KAV60 Schematics Document

Intel Diamondville Processor with Calistoga(945GSE) + DDRII + ICH7M

Security Classification		Compal Secret Data		Compal Electronics, Inc.	
Issued Date	2006/08/18	Deciphered Date	2007/8/18	Title	Cover Page
THIS SHEET OF ENGINEERING DRAWING IS THE PROPRIETARY PROPERTY OF COMPAL ELECTRONICS, INC. AND CONTAINS CONFIDENTIAL AND TRADE SECRET INFORMATION. THIS SHEET MAY NOT BE TRANSFERRED FROM THE CUSTODY OF THE COMPETENT DIVISION OF R&D DEPARTMENT EXCEPT AS AUTHORIZED BY COMPAL ELECTRONICS, INC. NEITHER THIS SHEET NOR THE INFORMATION IT CONTAINS MAY BE USED BY OR DISCLOSED TO ANY THIRD PARTY WITHOUT PRIOR WRITTEN CONSENT OF COMPAL ELECTRONICS, INC.				Size B	Document Number
				KAV60 LA-5141P	
				Date	Sunday, February 22, 2009
				Sheet	1 of 40
				Rev	0.2

Model Name : KAV60
File Name : LA-5141P
P/N : DA60000BO00

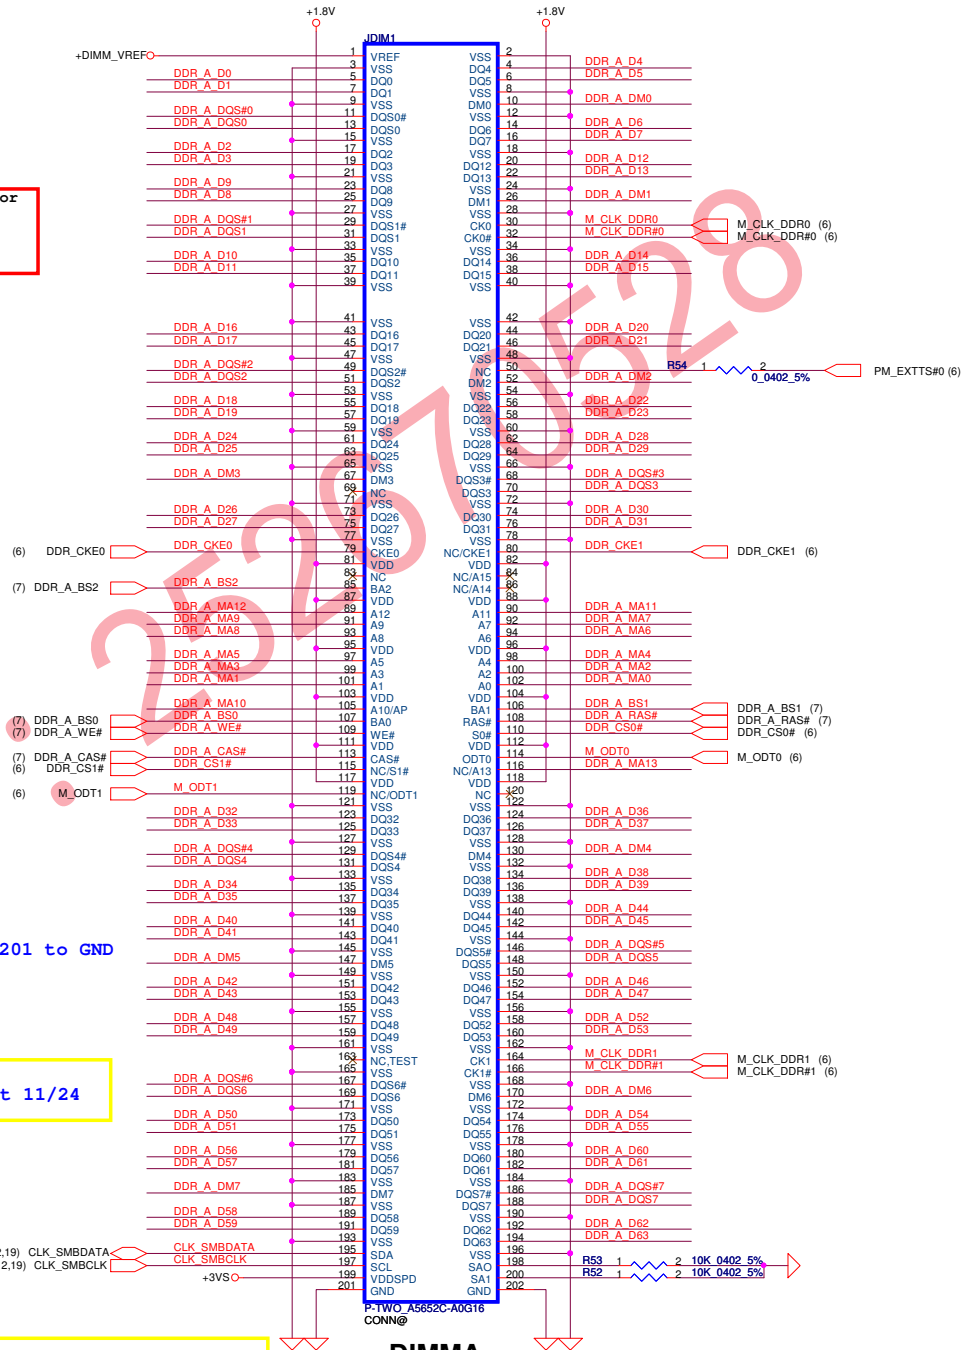
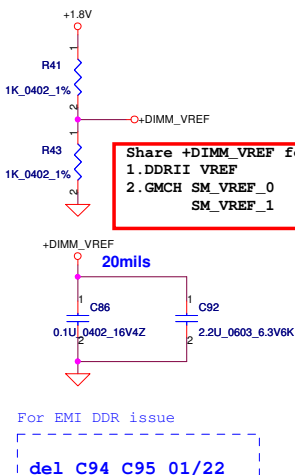
To be confirmed 11/14
add net name (+VCCP_D)
20mil 12/10

Mini-Express Card for WLAN

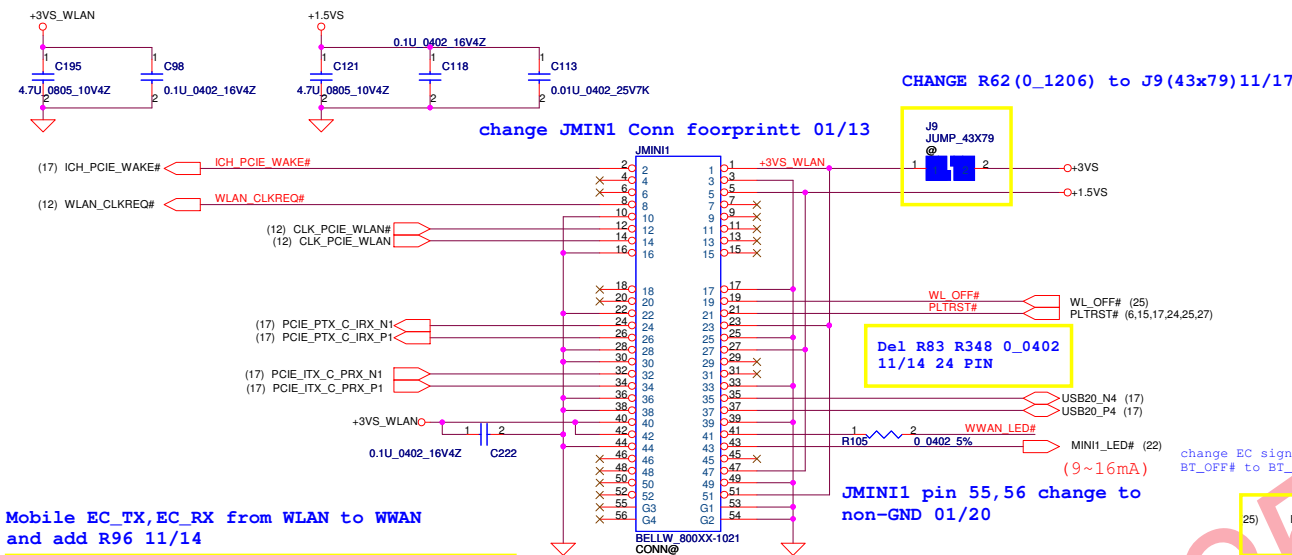
Mobile EC_TX,EC_RX from WLAN to WWAN
and add R96 11/14

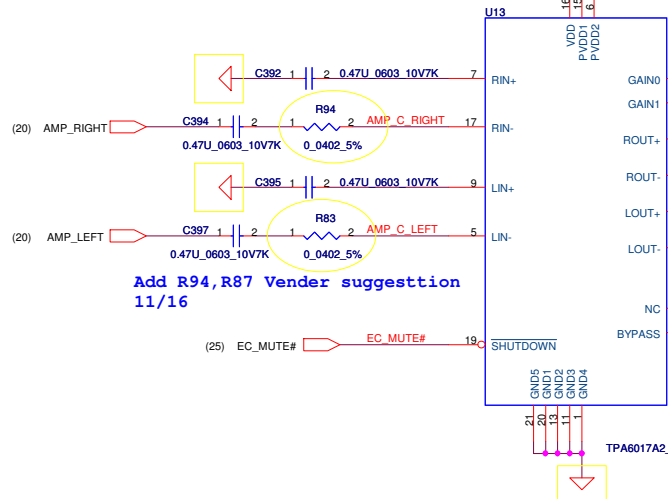
add J12 12/04

+5VS change to +5VALW 12/11

Add R94,R87 Vender suggestion 11/16

Int. Speaker Conn.

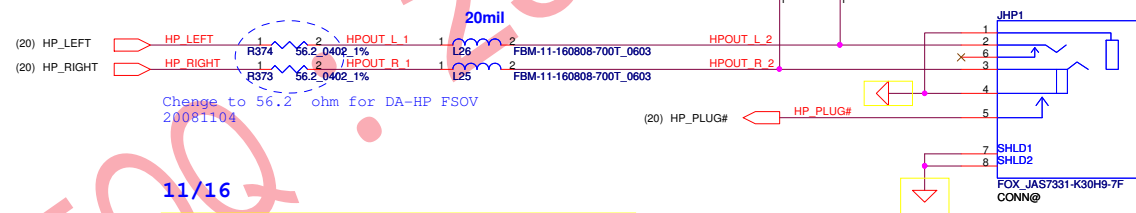
change JP20 Conn and pin design 11/26

del R388,R387,R386,R385,D10,D13 12/11

change JP20 Conn 01/16

SWAP JP20 01/20

LINE Out/Headphone Out

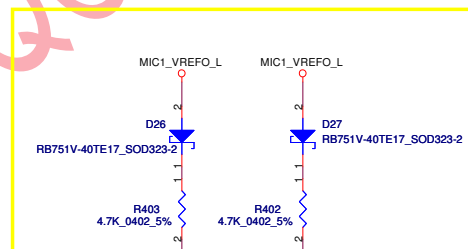
Change to 56.2 ohm for DA-HP FSOV 20081104

SATA&CARDREADER&USB Conn

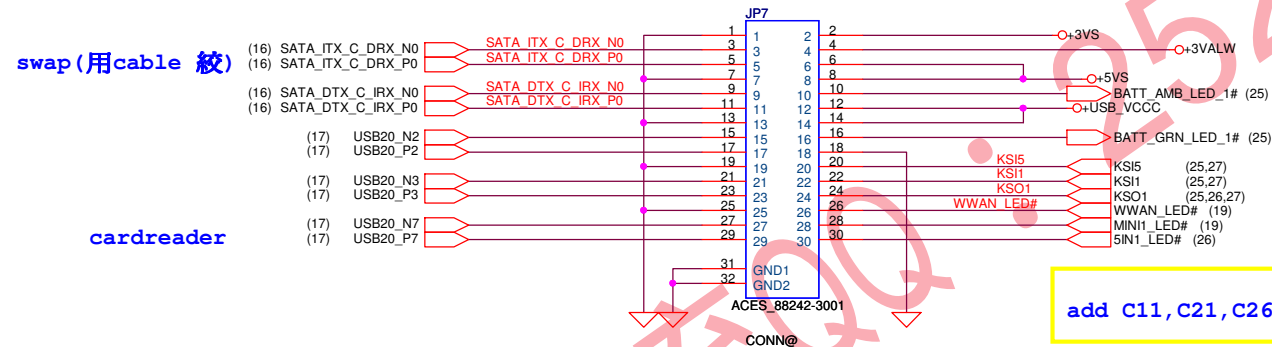
Move SATA HDD Conn to small board 11/21

SWAP JP7 pin define 12/03

+3VS_READER change to +3VALW 12/15

add net name BATT_AMB_LED#
BATT_GRN_LED# 12/15

add J15 J16 12/08

del J15,J16,C21 12/15

add C11,C21,C26,C27 for keypart 12/08

add C28 for keypart 01/14

del C11,C28,C26 01/21

del C26 02/03

ADD SATA&CARDREADER&USB Conn (JP7) 11/26

Atheros
AR8114A 10/100 LAN

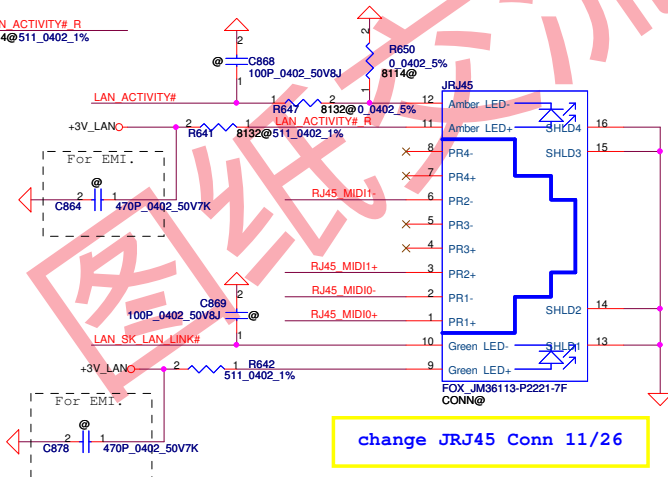
change R644 from 0603 to 0805 12/31
change R643 from 0603 to 0402 12/31
change C841 from 0603 to 0402 12/31
add R651 0_0402 02/03
change C841 from 0402 1U to 0603 1U 02/03

Chang C855 form 4.7U to 10U 11/16 vendor suggest

del C843,C844 12/02

change C852,C853,Y5 BOM structure 12/15
add C55 on page 24 12/15

del C55 12/16
change C852,C853 from 27p to 15p 01/23

change JRJ45 Conn 11/26

ADD C160 01/13

Chang C846 form 4.7U to 10U 11/16 vendor suggest

Chang C160 from 0603 to 0402 01/20

change BJT form MMJT9435T1G to MBT35200 11/16

change C847 from 0.1u to 1u 12/02

change L29,L30 from 0805 to 0603 12/31

del R637 R638 12/31

ON/OFF switch

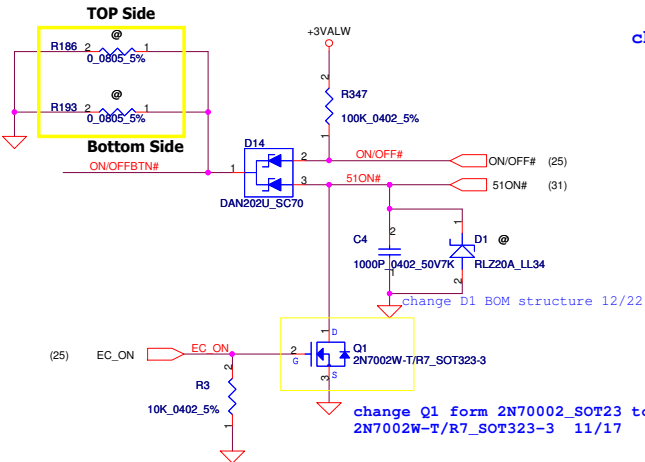
change J1,J3(43 x 79) to R186,R193(0_0805) 11/16

change JP2 Conn 12/01

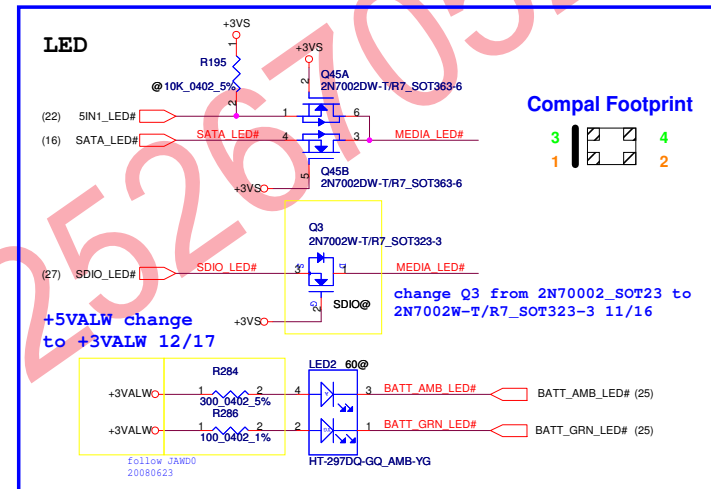
change JP2 Conn 11/25 ***To PWR/B Conn.***

change JP2 from 6 pin to 8 pin 11/21

Change PWR_LED and PWR_SUSP_LED
Net name 01/13

change R284 from 150 ohm to 300 ohm
R286 from 120 ohm to 100 ohm 01/23

change LED2 BOM
structure 02/18

DEL LID Switch 11/21

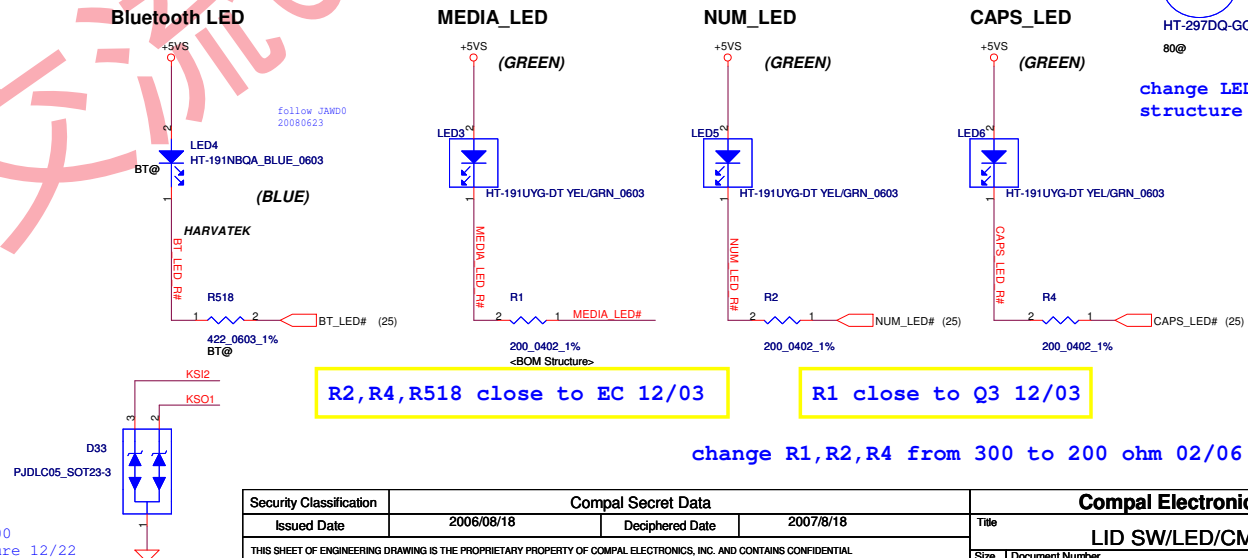
Change SW4 P/N to SN111005800 01/13

change D33 P/N from SC10T24C000
to SCA00000A00 and BOM structure 12/22

R2,R4,R518 close to EC 12/03

R1 close to Q3 12/03

change R1,R2,R4 from 300 to 200 ohm 02/06

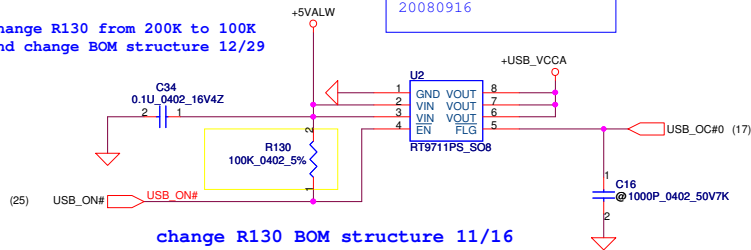
U2 Change to SA000033H00
12/24

Change R130 from 200K to 100K
and change BOM structure 12/29

change D29 P/N from SC300000000
to SC300000B00 and BOM structure 12/22

SWAP D29 Pin Define 12/10

del D29 ,L9,R144,R136 01/16

USB CONN. 1

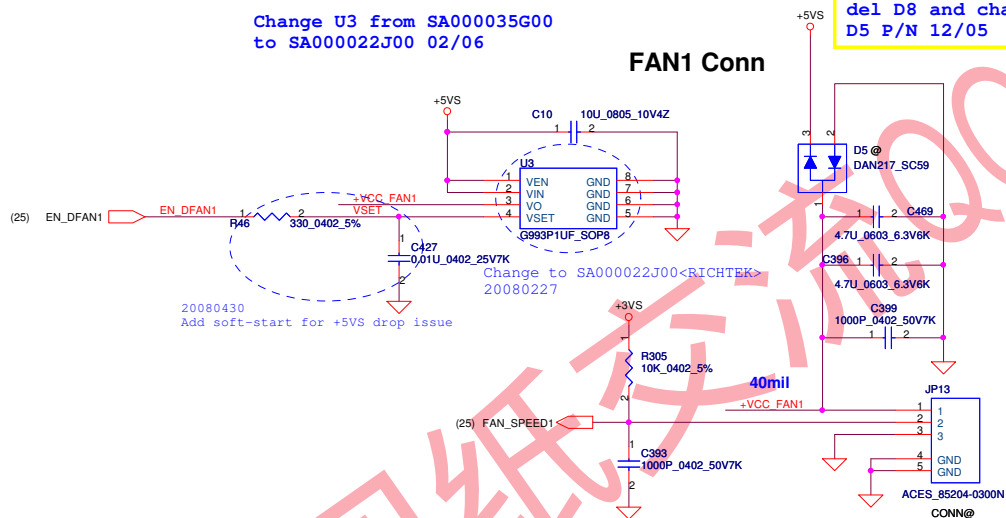
Change C231 P/N to SGA00001E00 01/13

U3 Change to SA000035G00
12/31

Change U3 from SA000035G00
to SA000022J00 02/06

change D5 BOM
structure 01/23

del D8 and change
D5 P/N 12/05

FAN1 Conn

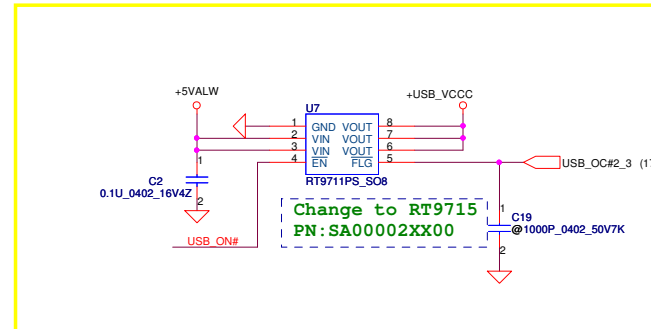
change C396 from 100U/0806 to 4.7U/0603 01/22
add C469 01/22

del JP3 11/26

add U7 11/26

U7 Change to SA000033H00
12/24

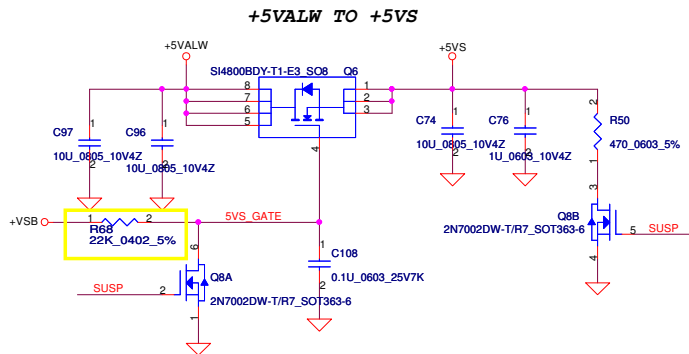
change R68 from 200K to 22K 12/10

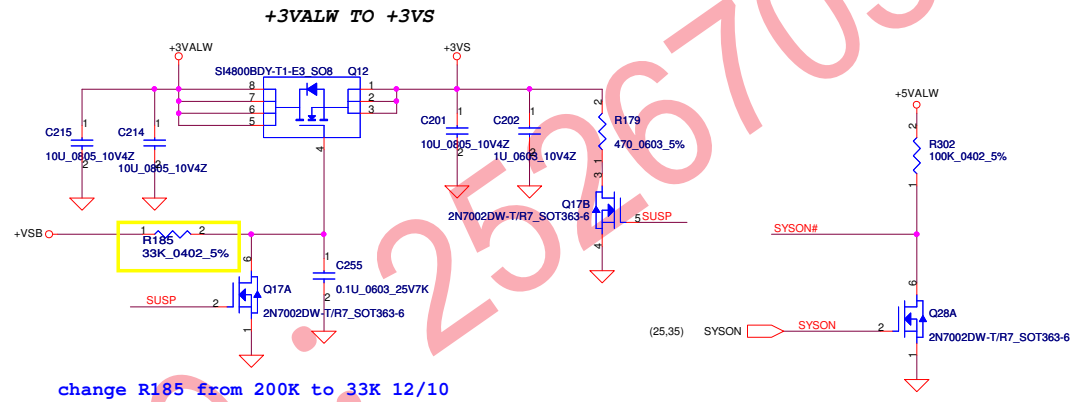
change R185 from 200K to 33K 12/10

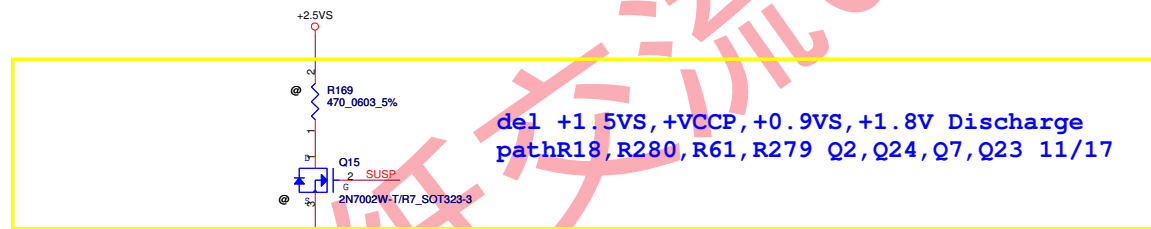
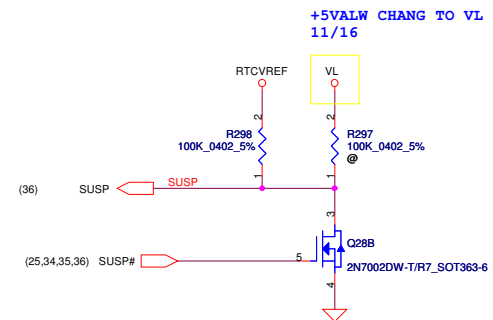
change Q2, Q15, Q24, Q7, Q23 from 2N7002W-T/R7_SOT23 to 2N7002W-T/R7_SOT323-3 11/17

change R18, R169, R280, R61, R279 Q2, Q15, Q24, Q7, Q7, Q23 BOM structure 11/16
